Intersection ID: 8373	Main Street: AUGUSTA_ST	Cross Street: LASALLE_ST	Location:	NW
ADA ID: 1DA765F7325C	Ramp Type: PerpDiag	Initial Pass/Fail: Fail	Overall Compliance: No	Severity Score: 35

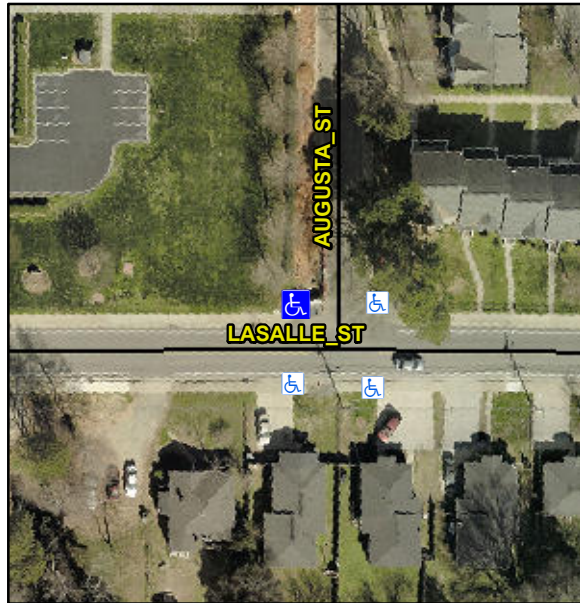
**Not Found, R304.5.1, R304.2.2,
R304.5.3**

Compliance	Description	Data	Compliance	Description	Data
N/A	Ramp Length (in)	59.0	No	Ramp Slope (%)	13.4
No	Ramp Width (in)	44.0	No	Ramp XSlope (%)	2.6
N/A	Flare Type LT	N/A	N/A	Flare Type RT	N/A
N/A	Flare Slope LT (%)	N/A	N/A	Flare Slope RT (%)	N/A
N/A	Flare Traversable LT?	N/A	N/A	Flare Traversable RT?	N/A
N/A	Landing Length (in)	N/A	N/A	DWS Provided?	N/A
N/A	Landing Width (in)	N/A	N/A	DWS Contrast?	N/A
N/A	Landing Slope (%)	N/A	N/A	DWS Length (in)	N/A
N/A	Landing X Slope (%)	N/A	N/A	DWS Full Width?	N/A
N/A	Landing Curb? (Y/N)	N/A	N/A	DWS Offset (in)	N/A
N/A	Shared Landing?	N/A			
N/A	Gutter Ponding?	N/A	N/A	Gutter Slope (%)	N/A
N/A	Gutter Lip Ht (in)	0.5	N/A	Gutter X Slope (%)	N/A
N/A	Painted X Walk1?	No	N/A	Painted X Walk2?	No
	X Walk 1 Direction	To S		X Walk 2 Direction	To E
N/A	X Walk 1 Width (in)	N/A	N/A	X Walk 2 Width (in)	N/A
	X Walk 1 Slope (%)	1.4		X Walk 2 Slope (%)	0.6
	X Walk 1 X Slope (%)	1.1		X Walk 2 X Slope (%)	1.1

Remove & Replace Curb Ramp With Two New Directional Ramps or Equivalent.
